Title - Sujet CD Howe Aménagement/Refit	
Solicitation No. - N° de l'invitation EP067-151357/A	Amendment No. - N° modif. 004
Client Reference No. - N° de référence du client 20151357	Date 2015-01-28
GETS Reference No. - N° de référence de SEAG PW-\$\$\$FG-340-66468	
File No. - N° de dossier fg340.EP067-151357	CCC No./N° CCC - FMS No./N° VME
Solicitation Closes - L'invitation prend fin at - à 02:00 PM on - le 2015-02-03	Time Zone Fuseau horaire Eastern Standard Time EST
F.O.B. - F.A.B. Plant-Usine: <input type="checkbox"/> Destination: <input checked="" type="checkbox"/> Other-Autre: <input type="checkbox"/>	
Address Enquiries to: - Adresser toutes questions à: Brouillet, Richard	Buyer Id - Id de l'acheteur fg340
Telephone No. - N° de téléphone (819) 956-0457 ()	FAX No. - N° de FAX (819) 956-8335
Destination - of Goods, Services, and Construction: Destination - des biens, services et construction: Édifice CD Howe/ CD Howe Building 235 rue Queen Street Ottawa, ON K1A 0H5

AMENDMENT 4 IS RAISED TO ATTACH ADDENDUM 4 AND 5

C.D. HOWE BUILDING, OTTAWA, ON
1W FIT UP AND M&E UPGRADE

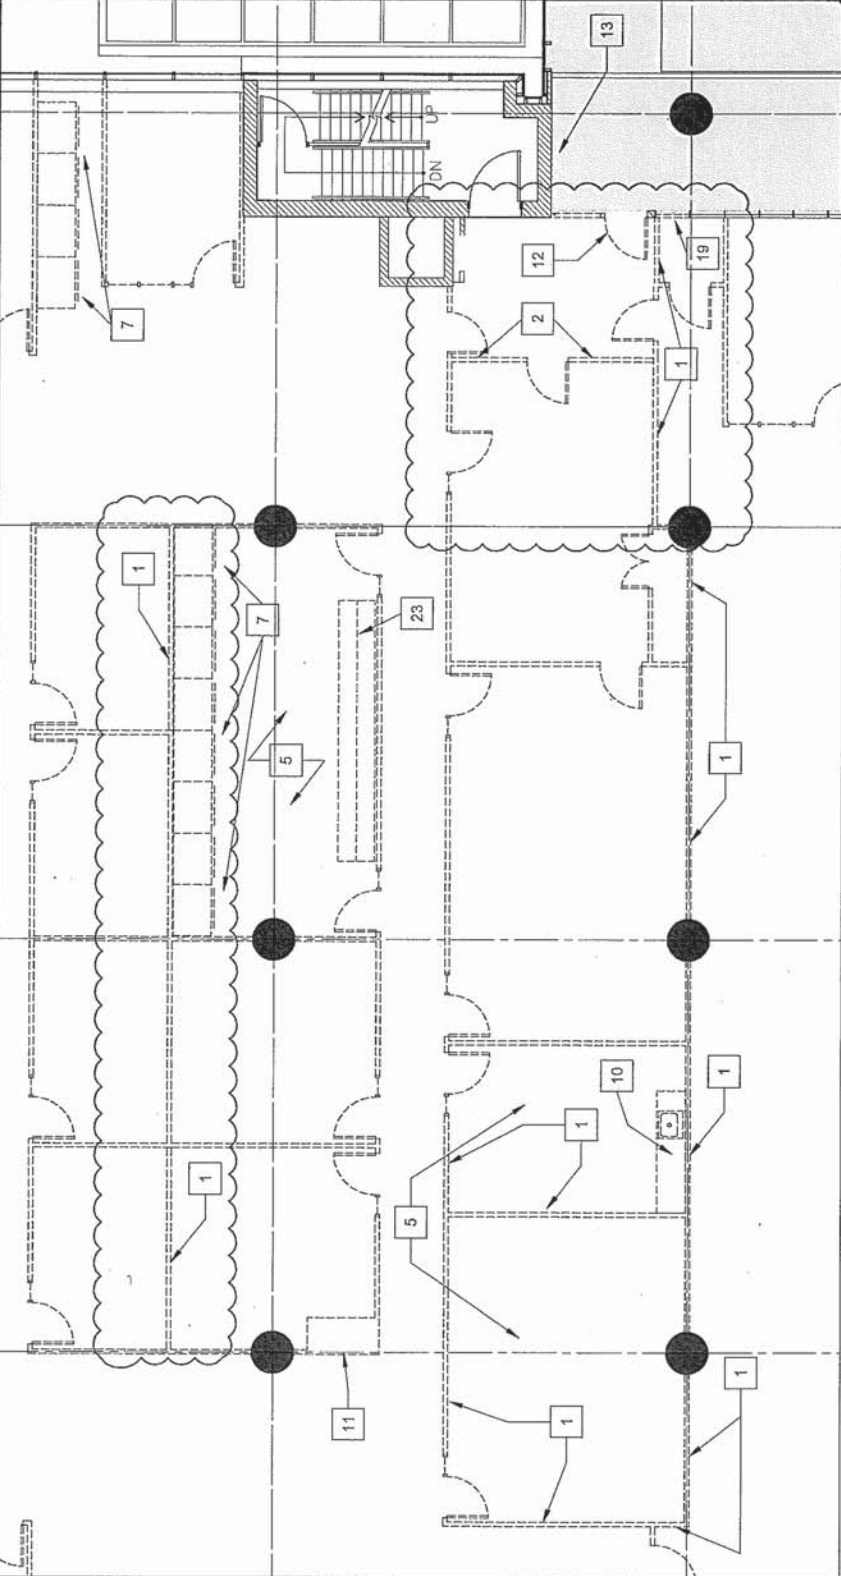
ADD Drawing Note 29 with the following:
29. REMOVE EXISTING SLAB TO SLAB PARTITION. (CAST IN PLACE CONCRETE) INCLUDING FLOOR BASE, WALL MOUNTED ACCESSORIES, DOORS, FRAMES, & SIDELIGHTS.
- .2 Refer to Detail **4/A111** (specifically the revision cloud), sketch ADD5-SK6 (attached):
ADD drawing note 1, 2 & 29, as shown in sketch ADD5-SK6.
- .3 Refer to Detail **5/A111** (specifically the revision clouds), sketch ADD5-SK7 (attached):
ADD drawing notes 1 & 2, as shown in sketch ADD5-SK7.

5
 A111
 1 WEST DEMOLITION
 PLAN (PARTIAL)
 SCALE 1:100
 DRAWING NOTES A111 - A & B:
 REVISED & SUPPLEMENTAL DWG. NOTES TO SHEET A111 A & B
 2. REMOVE EXISTING SLAB TO SLAB PARTITION, (GYPSUM BOARD/STEEL STUDS/GYPSUM BOARD) INCLUDING FLOOR BASE/WALL, MOUNTED ACCESSORIES, DOORS, FRAMES, & SIDELIGHTS.
